## Technical Memorandum

**SUBJECT:** Review of the Bryan Simsboro Aquifer Evaluation Report

**DATE:** August 2, 2023

Figure 2. Projected DFC Water Level Change at Proposed City of Bryan Well 20

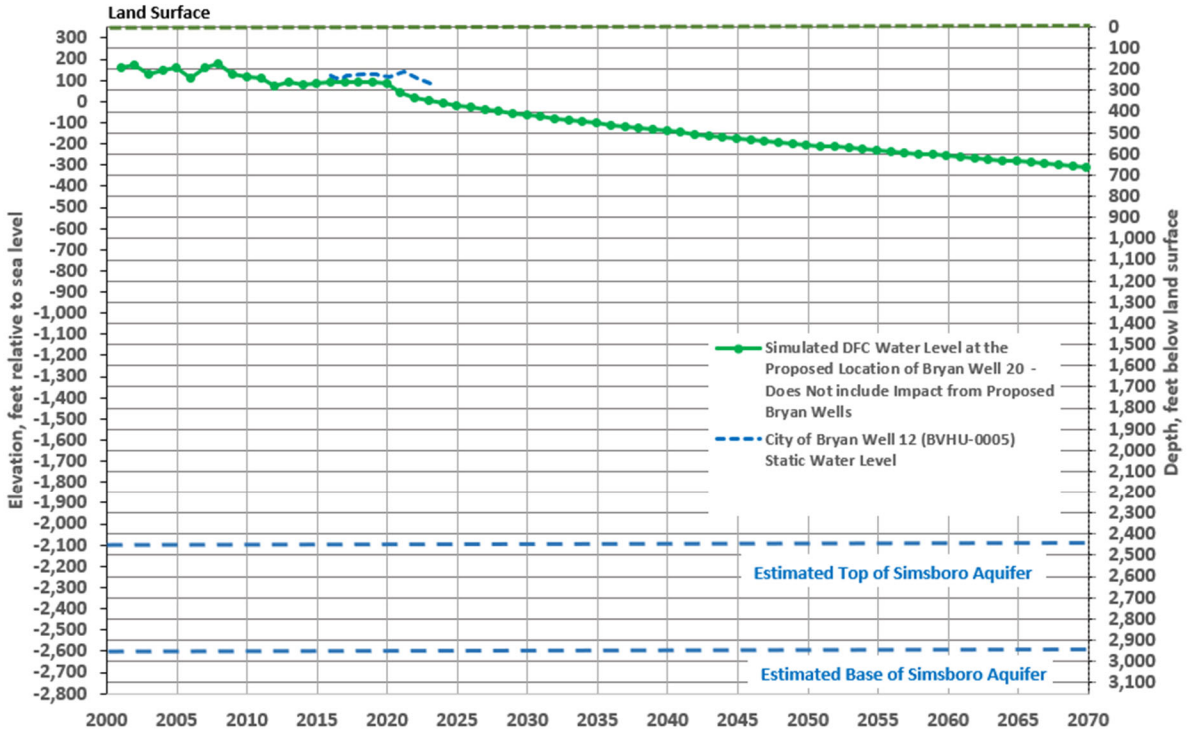
The graphs on Figures 2 through 5 illustrate the relationship between the land surface, estimated static water level through time and the estimated top and bottom of the Simsboro Aquifer based on review of available electric logs near the locations of the proposed wells.

Historical static water level measurements are also shown on Figures 2 and 3 for the City of Bryan Well 12 (BVHU-0005), which is located about 0.80 miles to the northeast of proposed Bryan Well 20 and about 0.83 miles to the north-northeast of proposed Bryan Well 21. The City of Bryan Well 12 screen sands of the Simsboro Aquifer in the depth interval of about 2,385 to 2,902 feet below land surface. Historical City of Bryan Well 15 (BVHU-0008) static water levels are shown on Figures 4 and 5. The City of Bryan Well 15 screen sands of the Simsboro Aquifer in the depth interval of about 2,389 to 2,867 feet below land surface. Well 15 is located about 0.60 miles north of proposed Bryan Well 22 and about 0.76 miles to the northeast of proposed Bryan Well 23.

Available drawdown in wells in the Simsboro Aquifer will decline over time based on the DFC simulation. In other words, the line with green dots does not include the impact of the proposed Bryan wells. Although not evaluated or discussed in detail herein, these levels of water level decline in wells and artesian head decline in the aquifer will have some impact on vertical leakage, intercepted discharge, reduction in confined and unconfined storage, and potential flow directions in the aquifer. Pumping by the proposed wells will have some of the same type effects on the aquifer.

Figure 12. Drawdown after one year of pumping using the TWDB GAM.

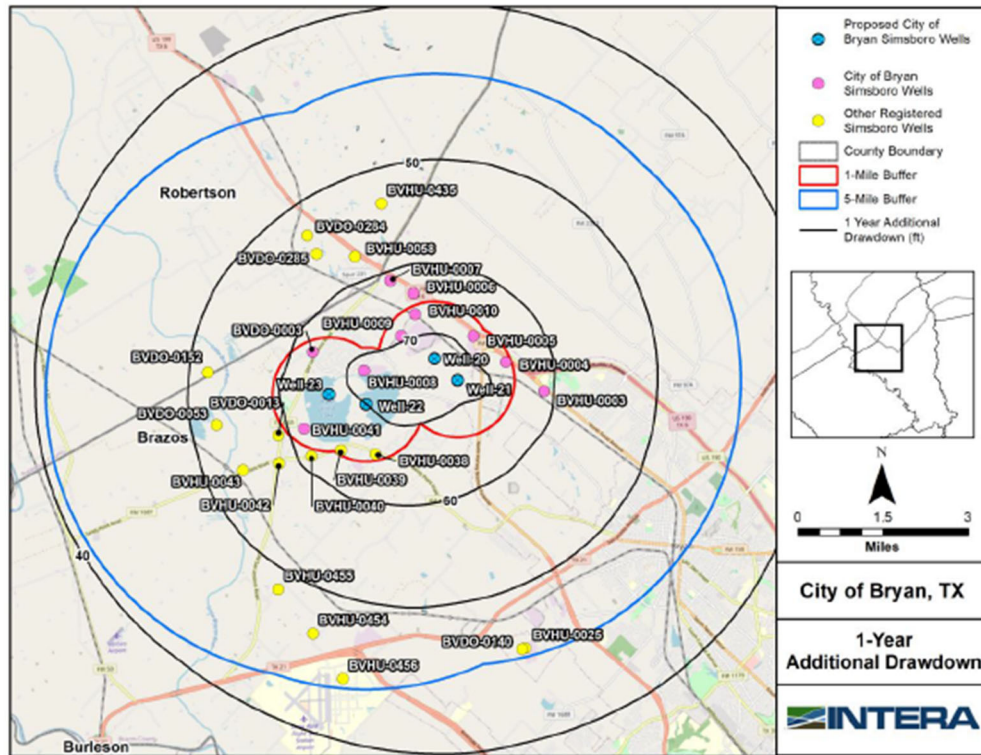
INTERA used the TWDB Central Portion of the Sparta, Queen City and Carrizo-Wilcox Aquifer GAM to estimate drawdown that results from continuously pumping the proposed City of Bryan wells at a combined rate of 14,204 ac-ft/yr for 1 year and 10 years. A copy of the INTERA 1-year and 10-year GAM simulated drawdown illustrations from the AER (INTERA Figures 12 and 13) are attached to this memorandum.

The AGS GAM simulation results after 1 and 10 years of pumping 14,204 ac-ft/yr from the proposed City of Bryan wells show drawdown estimates that are generally similar to INTERA’s results. AGS was able to replicate the drawdowns at distance after 1-year of pumping (about 40 to 45 feet drawdown at 5 miles and about 60 to 70 feet of drawdown at 1 mile) and 10-years of pumping (about 55 to 65 feet drawdown at 5 miles and about 75 to 85 feet of drawdown at 1 mile). AGS estimated a drawdown value that is about 5 feet more than INTERA at proposed Well 23 in the 1-year and 10-year simulations. This minor difference may be attributed to differences in contouring the simulation results.
